TO: Bob Shavelson, Executive Director, Cook Inletkeeper

FROM: Briana Mordick, Senior Scientist, Natural Resources Defense Council

SUBJECT: BlueCrest Alaska Operating LLC 10-403 Application for Fracture Operations: Horizontal Production Well H16

DATE: 7 December 2016

# BlueCrest Wells

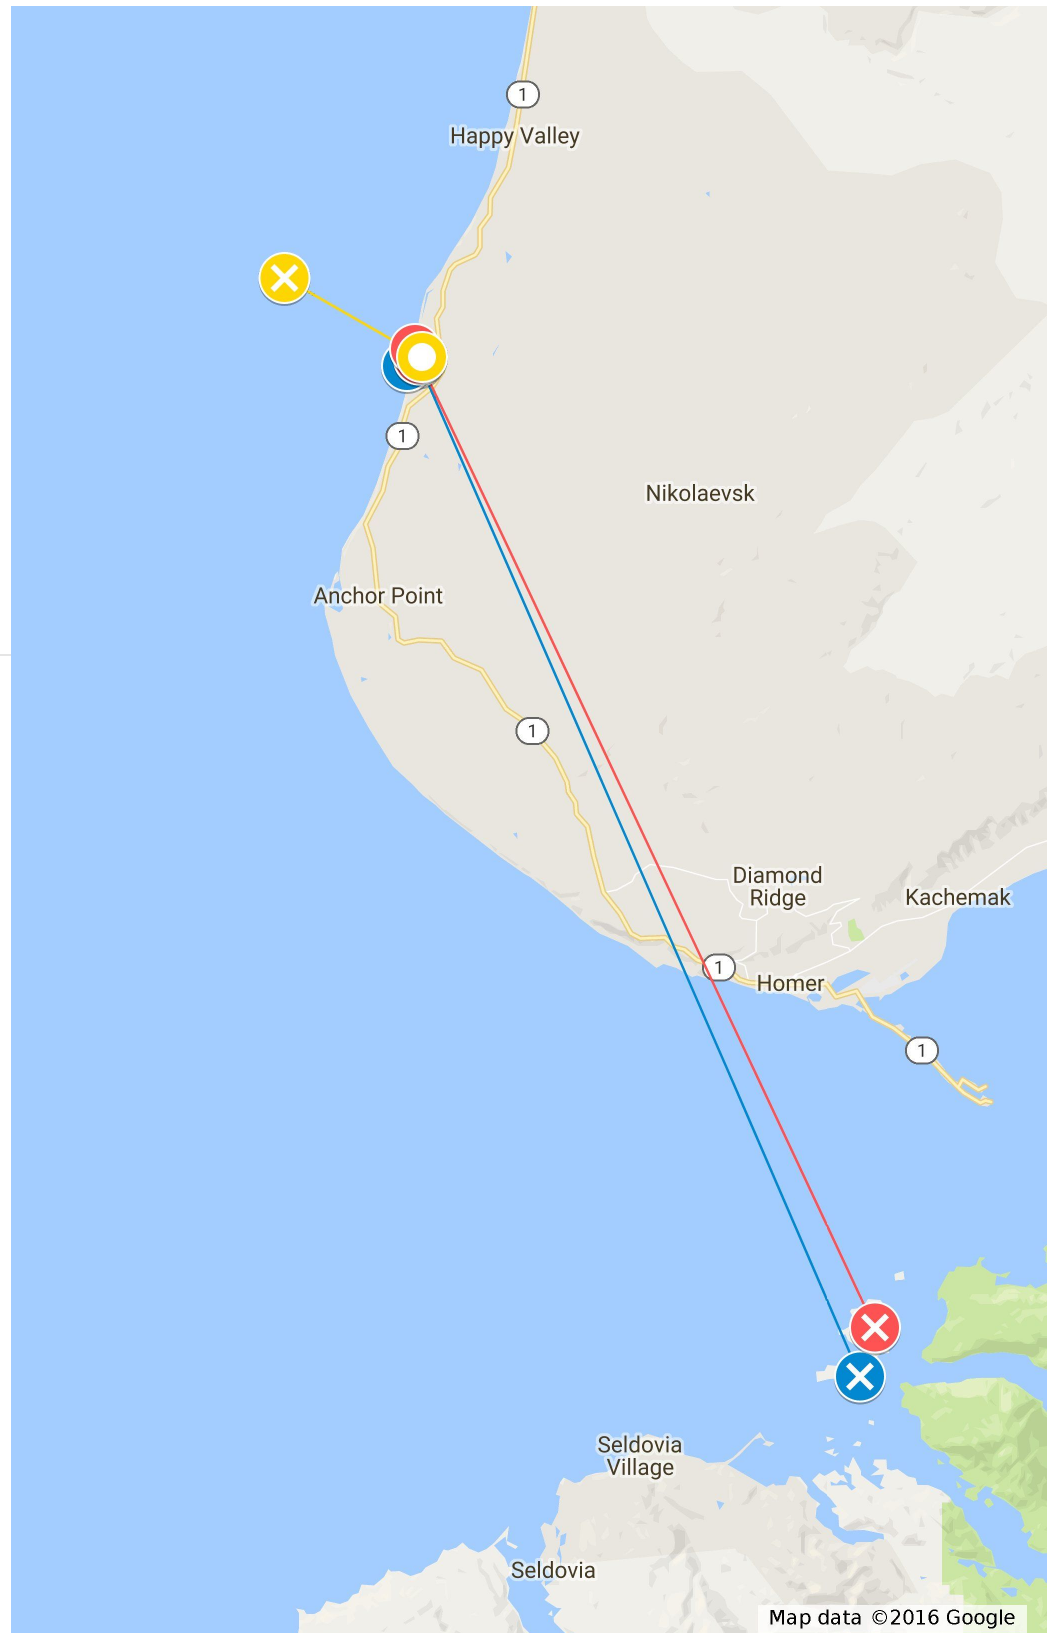
Finally, the geospatial coordinates for the bottomhole locations of the two Class I disposal wells, DSP01 and DSP02 appear to have been listed incorrectly in the permit application (specifically, in Attachment 04: UIC Permit AK11016-A). The coordinates listed put the bottomhole locations more than 25 miles from the surface locations (see map on page 6). BlueCrest should provide accurate coordinates for the surface and bottomhole locations.
